STANDARD-TRIUMPH MOTOR COMPANY, INC.

BULLETIN T-63-25

SUBJECT: SPORTS SIX & SPITFIRE
FRONT WHEEL BEARINGS

DATE: MARCH 20, 1963

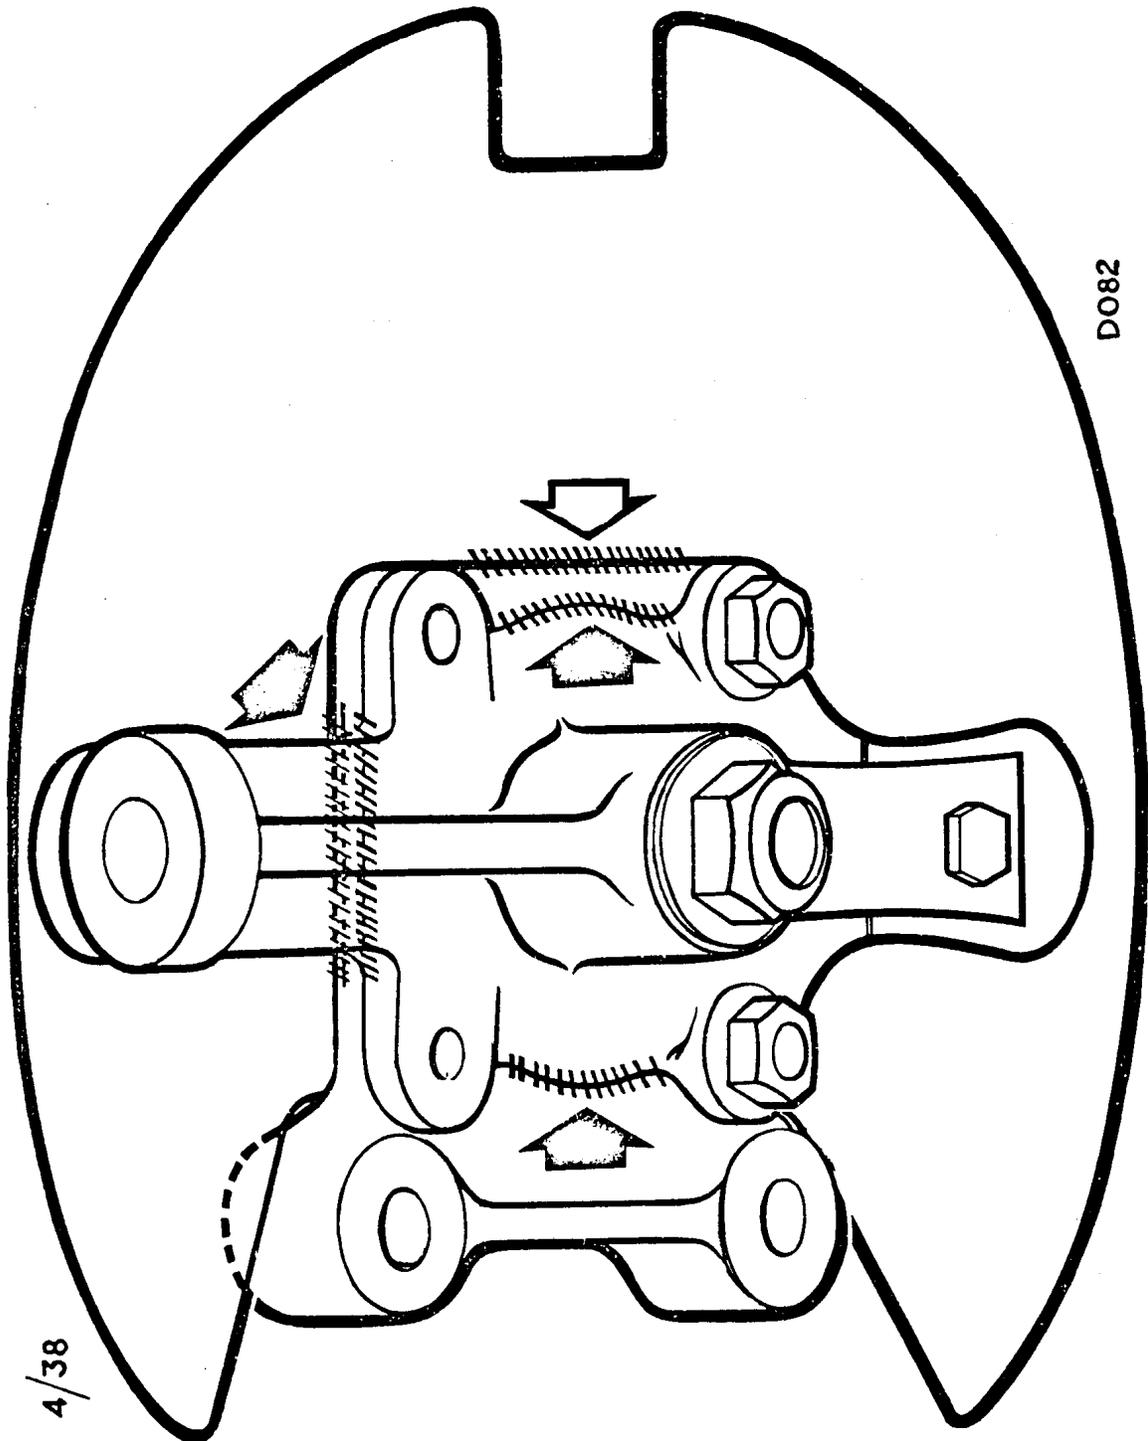
Water may enter the front hubs between the dust shield and caliper mounting bracket and damage the hub inner bearing on Spitfire and Sports Six models equipped with disc brakes. The hub outer bearing is seldom affected.

- (a) Dismantle the front hub assemblies, renew damaged bearings and discard the felt seals; these will be impregnated with water.
- (b) Thoroughly coat the faces of the new felt seals with approved hub grease. Reassemble the hubs.
- (c) Wire-brush the faces in the area of the caliper mounting plate and seal the gaps on the three sides with a suitable sealer such as "Permatex Form A Gasket."
- (d) Place a dab of red paint on the hub caps to indicate that the modification has been effected.

1. The sealing operation was introduced in production at (approx.)
Commission Numbers HB-6800 -FC-1675

The exact incorporation Commission Numbers referred in Page 1 of this
Bulletin have been confirmed as FC-1936 Spitfire and HB-6835 Sports Six
and therefore, no action will be necessary after these numbers.

Future production from FC-2393 and HB-7082 will incorporate a rubber seal
between the dust shield and caliper mounting bracket. This modification
cannot be applied to prior commission numbers.
